ADDENDUM NO. 1

Bid #1506
ORANGE EDUCATION CENTER PORTABLES PHASE II
at
ORANGE EDUCATION CENTER

Project ID #3762, DSA #04-125366

ADDENDUM 1

A5.15-2

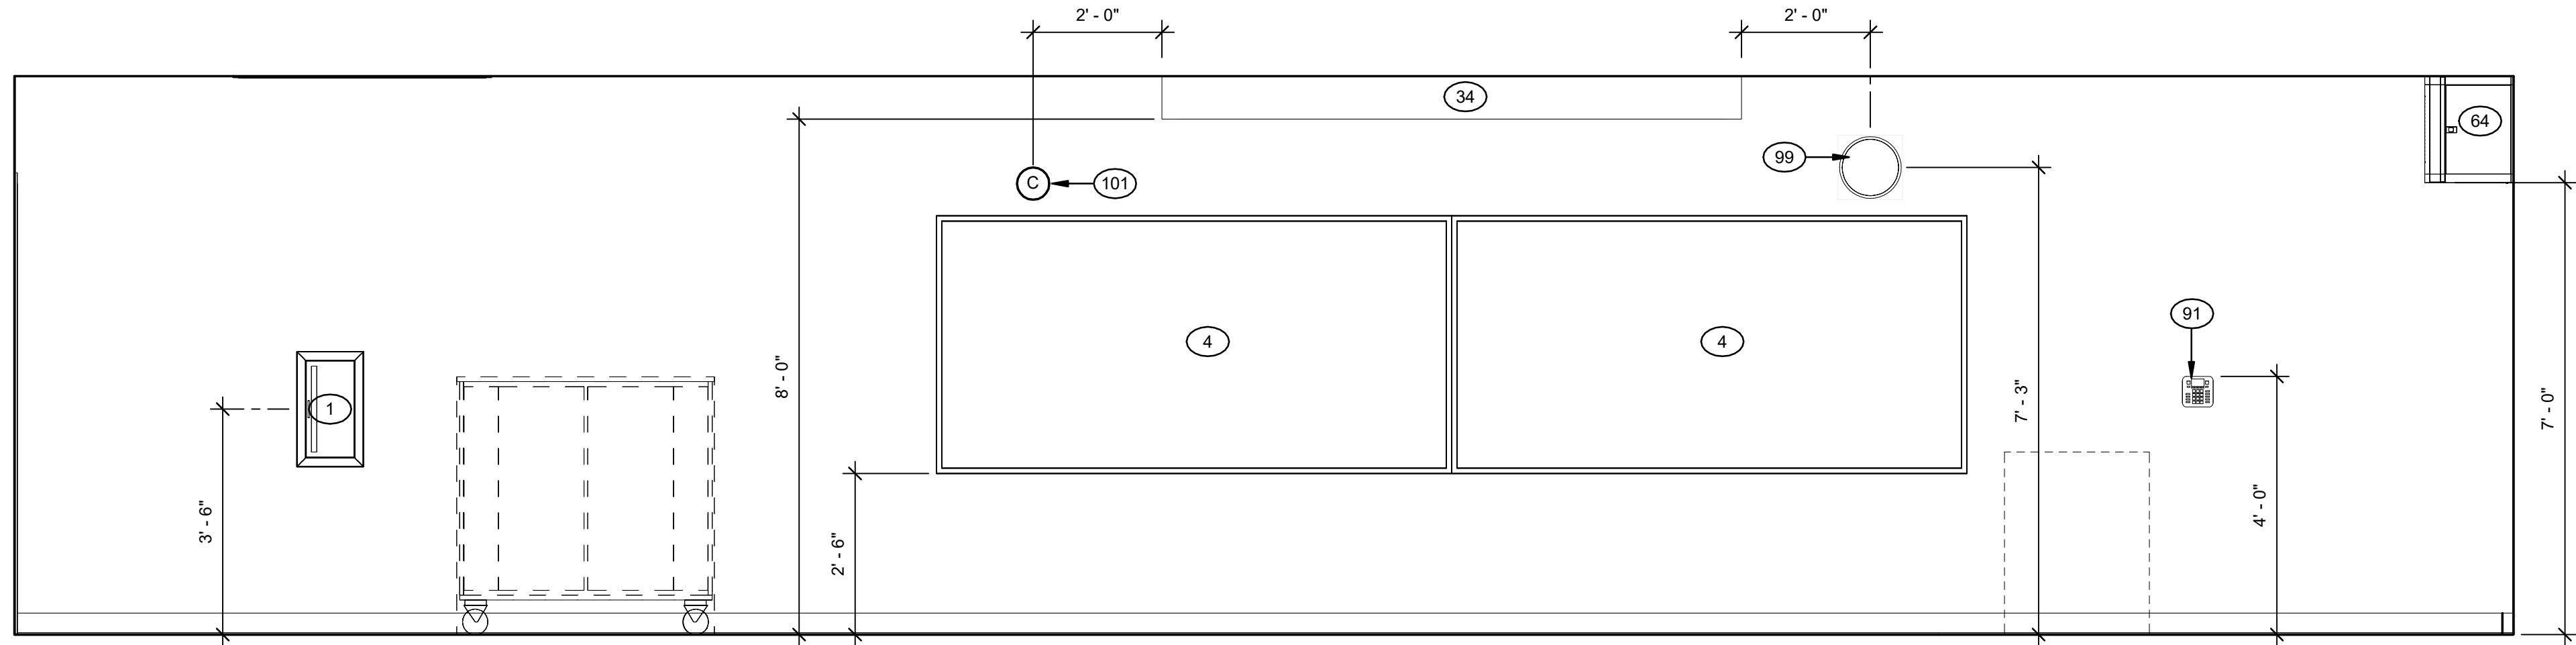
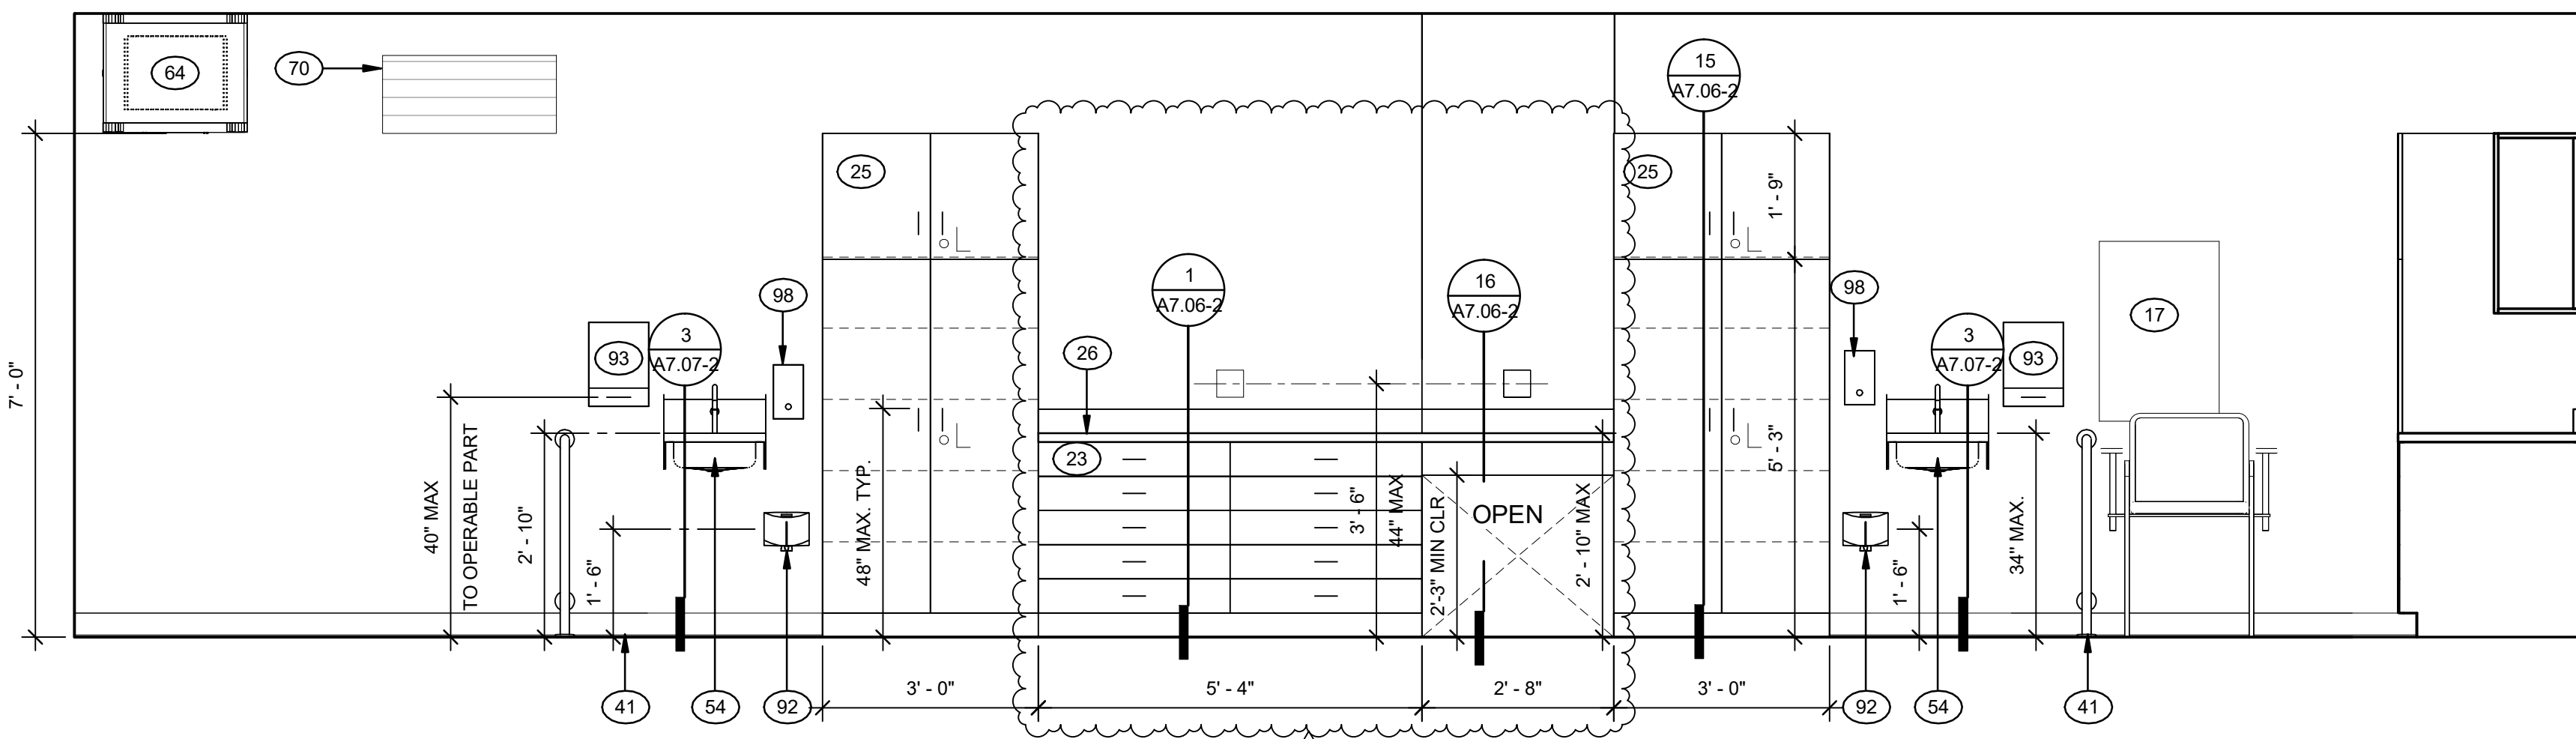
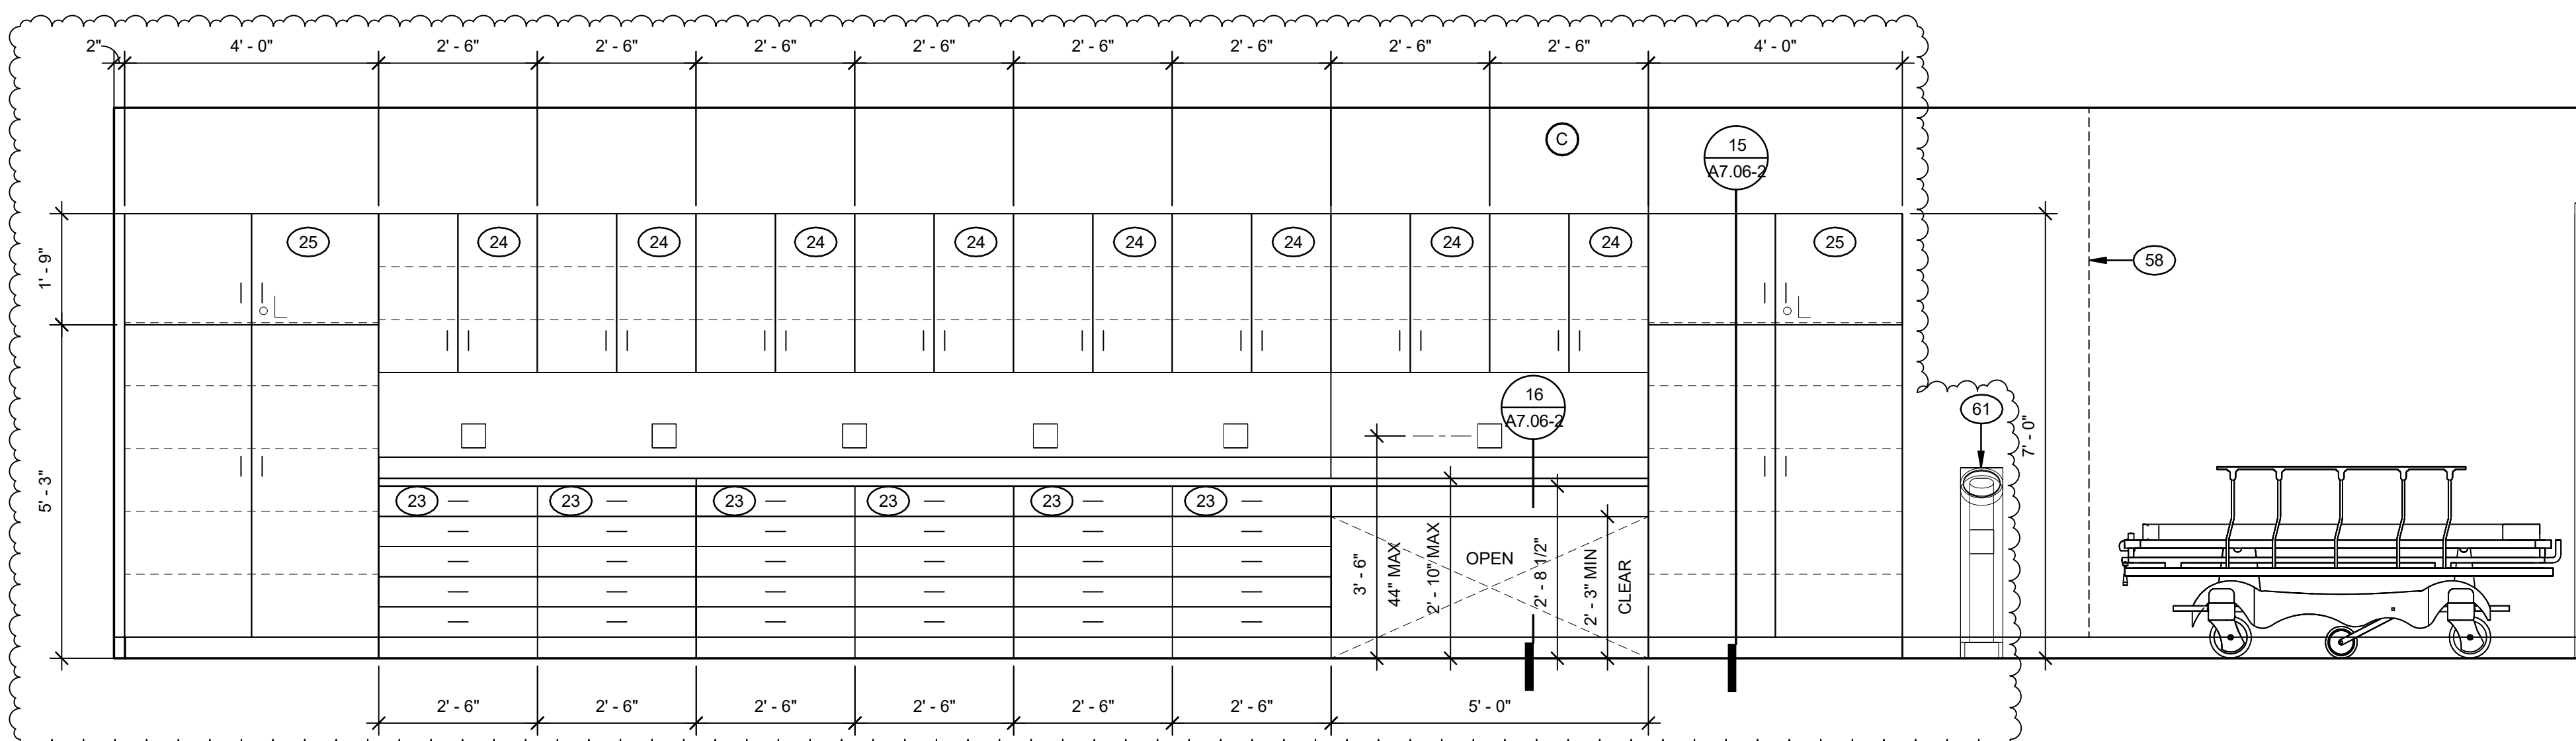
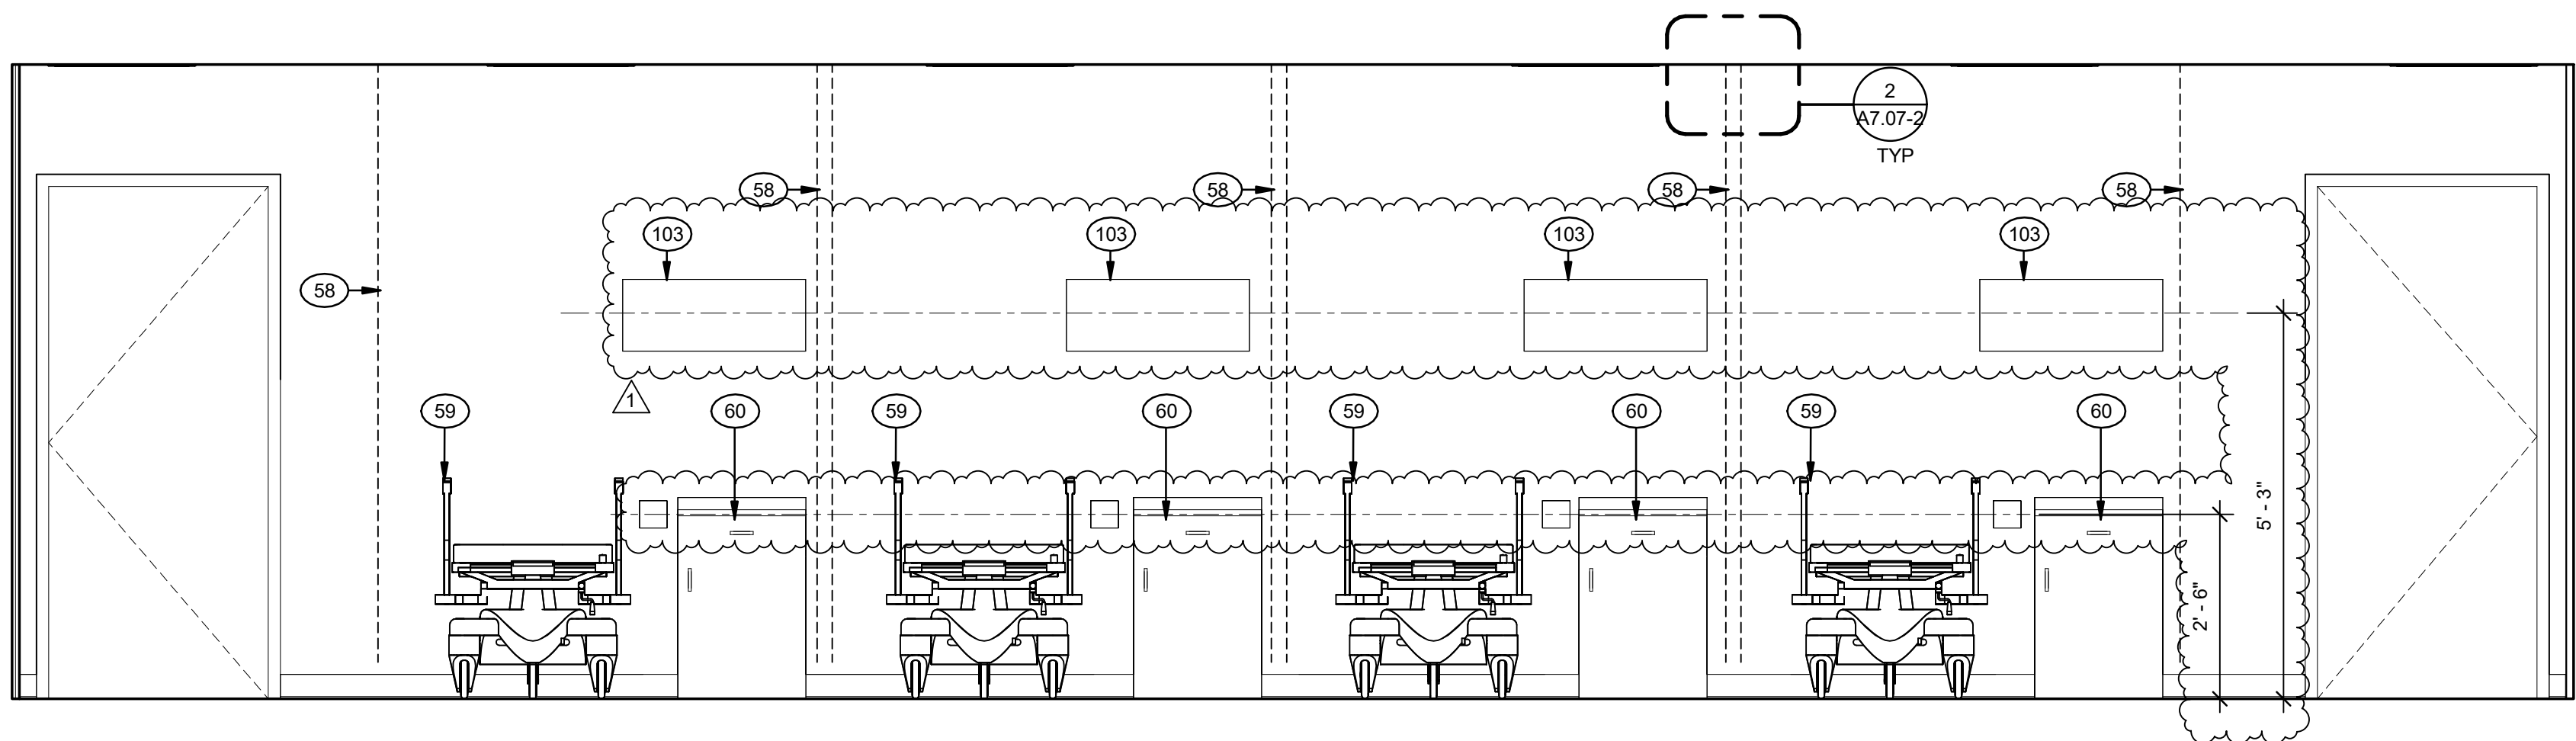
- D. Wall mounted medical equipment added at hospital bed headboard to clarify function and adjacencies.
6. **A5.15-2:**
 - A. Portable 207 has casework configuration modifications to accommodate program needs per 9/10/26 meeting with the user group. All casework (cabinets and drawers) in Portable 207 shall have locks.

- B. Portable equipment has been relocated per user group preferences.
 - C. Wall mounted medical equipment added at hospital bed headboard to clarify function and adjacencies.

- D. Added in Interior Elevation General Note that all cabinet doors and drawers must be lockable.
7. **A5.16-2:**
 - A. All casework (cabinets and drawers) in Portable 208 shall have locks.
